**PLANNED UNIT DEVELOPMENT
ZONING AMENDMENT
ZONING AMENDMENT &
SIDEWLAK WAIVER STAFF REPORT**

Date: December 4, 2014

<u>NAME</u>	Board of Water and Sewer Commissioners of the City of Mobile
<u>DEVELOPMENT NAME</u>	MAWSS Park Forest Facility
<u>LOCATION</u>	4725 Moffett Road (South side of Moffett Road at the South terminus of Shelton Beach Road Extension)
<u>CITY COUNCIL DISTRICT</u>	District 7
<u>PRESENT ZONING</u>	B-3, Community Business District, and R-1, Single-Family Residential District.
<u>AREA OF PROPERTY</u>	19.2± Acres
<u>CONTEMPLATED USE</u>	<p>Planned Unit Development Approval to allow shared access and parking between two building sites; Rezoning from R-1, Single-Family Residential District, and B-3, Community Business District, to B-3, Community Business District, to eliminate split zoning on a legal lot of record; Rezoning from R-1, Single-Family Residential District, to B-3, Community Business District, to allow the expansion of an existing parking lot for a water treatment facility; and Sidewalk Waiver to waive construction of a sidewalk along Moffett Road and Forest Hill Drive.</p> <p>It should be noted, however, that any use permitted in the proposed district w

SITE PLAN

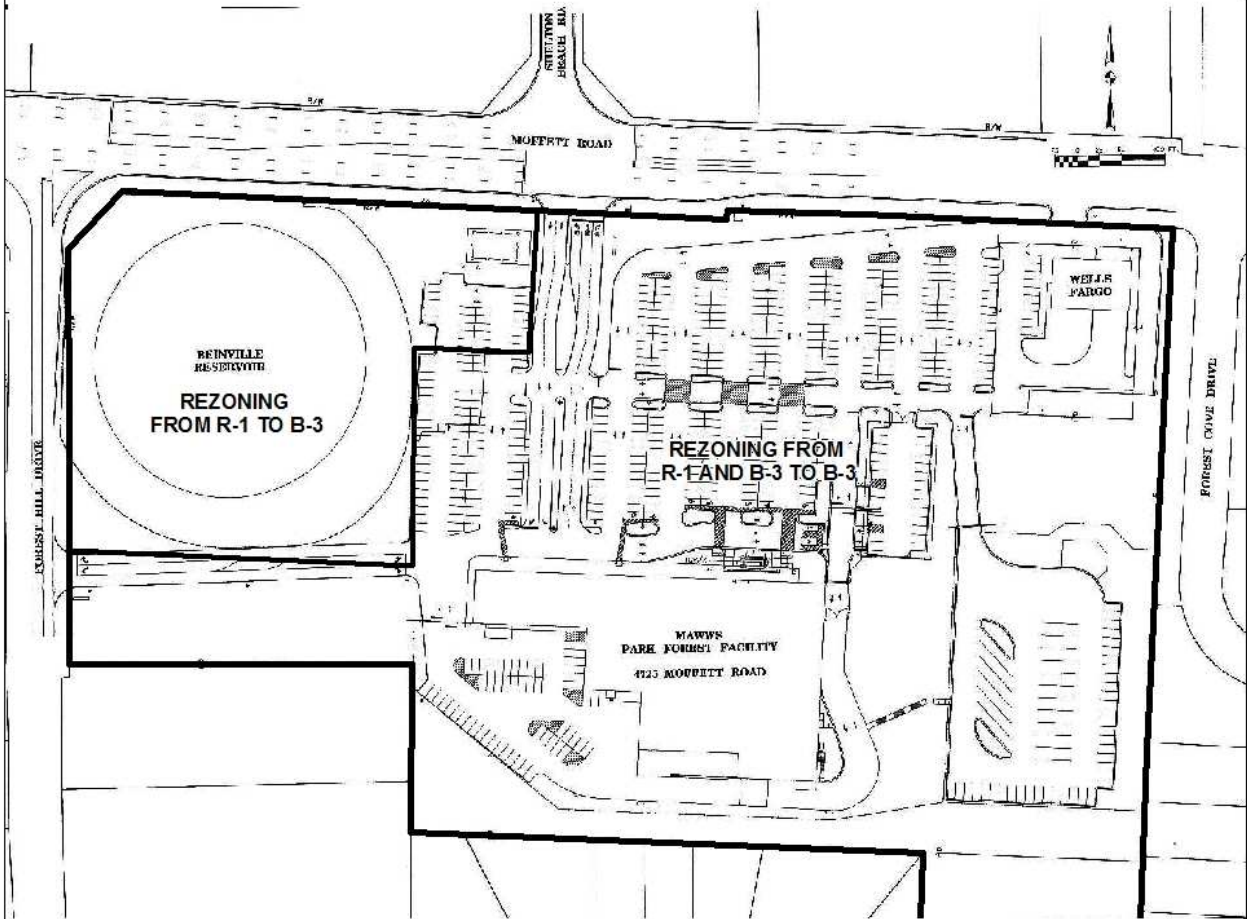
The site plan indicates the property line for the reservoir parcel encroaches onto the existing access drive from Forest Hill Drive. Therefore, this shared access would also be covered by the PUD. Also indicated is an encroachment of the reservoir fencing along Forest Hill Drive and

Moffett Road into the rights-of-way along both streets. The allowance of such to remain should be coordinated with the Right-of-Way Division of City Engineering and ALDOT.

Should the Sidewalk Waiver request be denied, the site plan should be revised to indicate a compliant sidewalk within the right-of-way. The site plan did not indicate a compliant dumpster and pad, nor was there a note on the site plan stating that refuse collection will be either by curb-side pickup or private collection services. Therefore, the site plan should be revised to indicate dumpster compliance or have a note added covering refuse collection. No information was provided regarding the lighting for the site. Therefore, a lighting plan regarding the new parking area lighting fixtures (including photometrics), indicating the locations, and submittal of information regarding how any existing site lighting will be modified to comply with the requirements of Sections 64-4.A.2., 64-6.A.3.c. and 64-6.A.8. of the Zoning Ordinance should be provided.

- 1) coordination with the Right-of-Way Division of City Engineering and ALDOT concerning the allowance of the fence encroachment into the rights-of-way along Forest Hill Drive and Moffett Road to remain;

- 2) revision of the site plan to indicate dumpster and pad compliance, or the placement of a note on the site plan stating that refuse collection will be either by curb-side pickup or private collection services;

- 9) revision of the site plan to provide a sidewalk in the right-of-way should the Sidewalk Waiver request be denied;
- 10) submission and approval of two (2) copies of a revised site plan prior to submittal for permits for Land Disturbance;

SECTION ON MOFFETT ROAD NEAR ENTRANCE DRIVE
(LOOKING EAST)

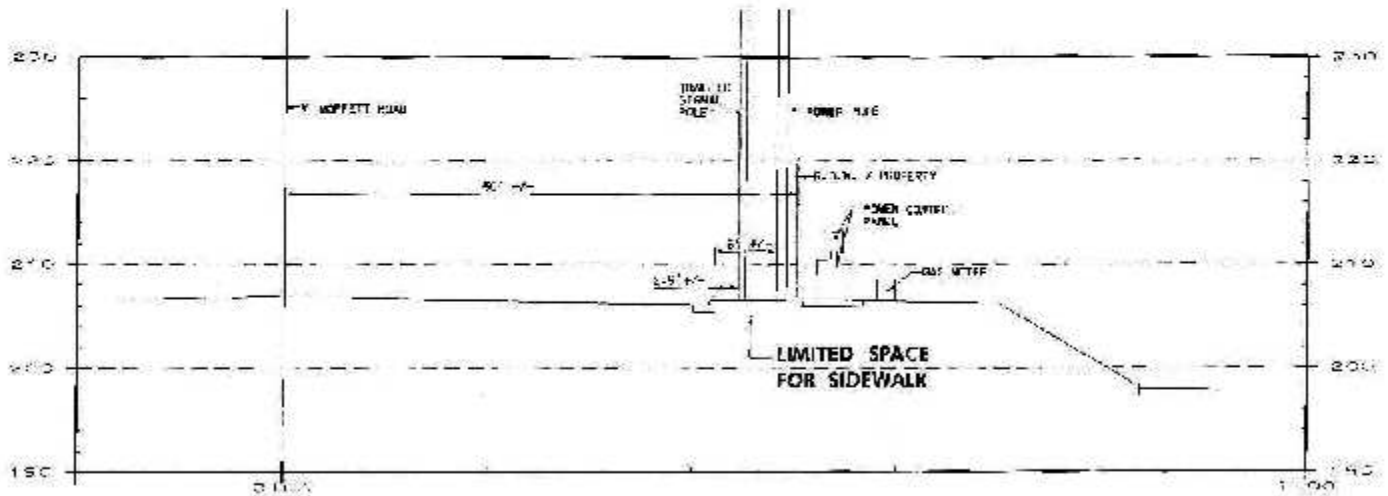
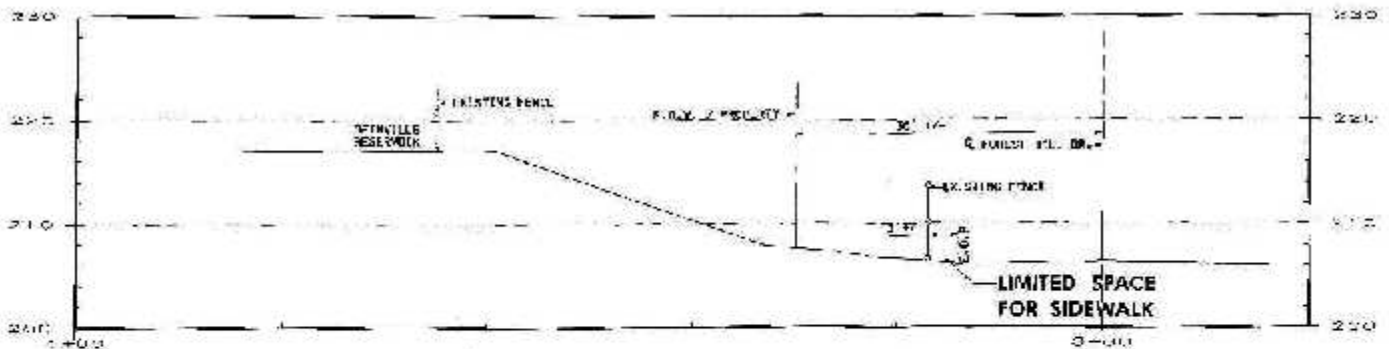
Sidewalk Waiver: Due to the existing limited roadside space availability at the SE corner of Moffett Rd. and Forest Hill Dr. which would prohibit the extension of a sidewalk in the future, and the existing topography along Moffett Road, it is recommended that this request be approved.

Pertaining to the Sidewalk Waiver request, it should be pointed out that the Mobile City Council adopted a “complete streets” policy on May 31, 2011. The purpose of the complete streets policy is to support the design and construction of streets to enable safe access to all users, including pedestrians, bicyclists, transit riders, motorists, commercial and emergency vehicles, and for people of all ages and abilities. A waiver of the sidewalk, as requested, will limit accessibility for pedestrians, transit riders and cyclists. However, as City Engineering has determined that, due to the existing limited roadside space availability at the Southeast corner of Moffett Rd. and Forest Hill Dr. which would prohibit the extension of a sidewalk in the future, and the existing topography along Moffett Road, it is recommended that this request be approved.

Sidewalk Waiver: Based upon the preceding, this request is recommended for approval.
